HEGER DRY DOCK, INC

17-11L

January 19, 2017

Re: Docking of Tandem Barges on Eureka

Loading condition assumptions:

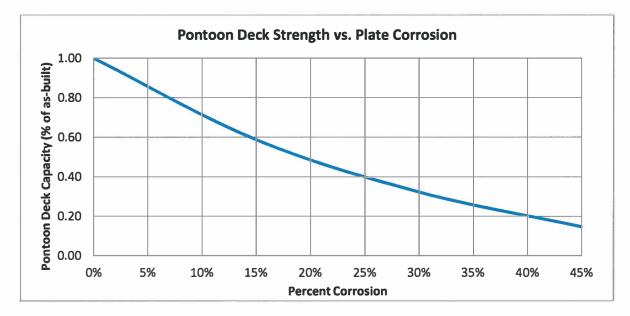
- Phase 5 condition, dock at 15.64 ft draft
- Internal water level = 10 ft above dock keel
- 7.0 kip/ft load applied at 9' and 23' off dock centerline
- Pontoon Deck thickness = 0.219in (45% corroded) See Reference (2)
- Transverse Frames and WT BHD structure 25% corroded (conservative estimate no data)
- Pontoon Bottom thickness = 0.306in (30% corroded) See Reference (3)

The result of the transverse bending analysis show that the combine compressive stress applied to the pontoon deck is approximately 1,000 psi.

The transverse bending analysis of the barge docking, however, shows the maximum applied stress of 1,000 psi is less than the calculated compressive strength of 2,520 psi rendering it acceptable. Note that this calculation assumes the dock is ballasted correctly and is only applicable to the specifically addressed docking presented in this letter.

ENCLOSURE 2 Pontoon Deck Stiffener Fracture Map

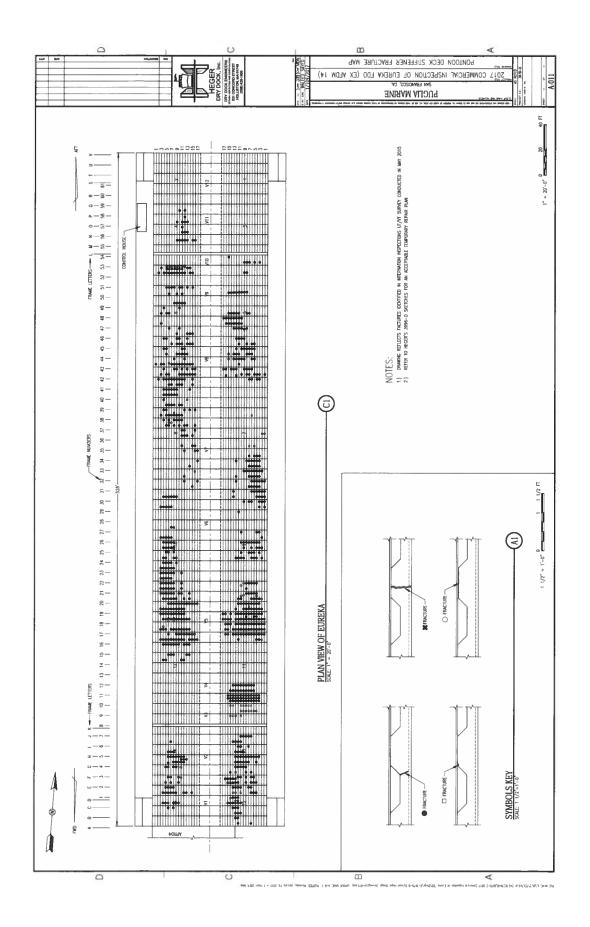
The EUREKA's pontoon deck stiffeners, however, have a widespread condition of fractures to the channel stiffeners in way of the serrated notches. A fracture in the serrated channel creates a discontinuity in the flow of bending stresses and changes the boundary condition of the stiffener beam from a fixed-fixed condition to two independent cantilevered beams overhanging from the supporting transverse frame. These cantilevered beams are significantly weaker and are assumed to take no load. As a result of the failure, the hydrostatic load is redistributed to adjacent stiffeners,

The latest 2017 HEGER inspection of the EUREKA pontoon deck found that the typical condition was for multiple adjacent pontoon deck stiffeners to be fracture. This is an UNSATISFACTORY condition to resist the head pressures required of the tandem barge docking addressed in this letter.

- Fracture of any kind in two(2) adjacent pontoon deck stiffeners
- More than one(1) fracture of any kind in a single pontoon deck stiffener between transverse frames.

There are four(4) different types of stiffener fractures occurring on the pontoon deck stiffeners. An acceptable short term pontoon deck stiffener repair plan for each fracture type is attached in Enclosure (3). Pontoon deck stiffeners should be repaired in accordance with the repair plan to eliminate the unsatisfactory conditions stated above. If staging is erected in a tank to repair deck stiffeners, it is recommended all stiffeners in the vicinity be repaired.
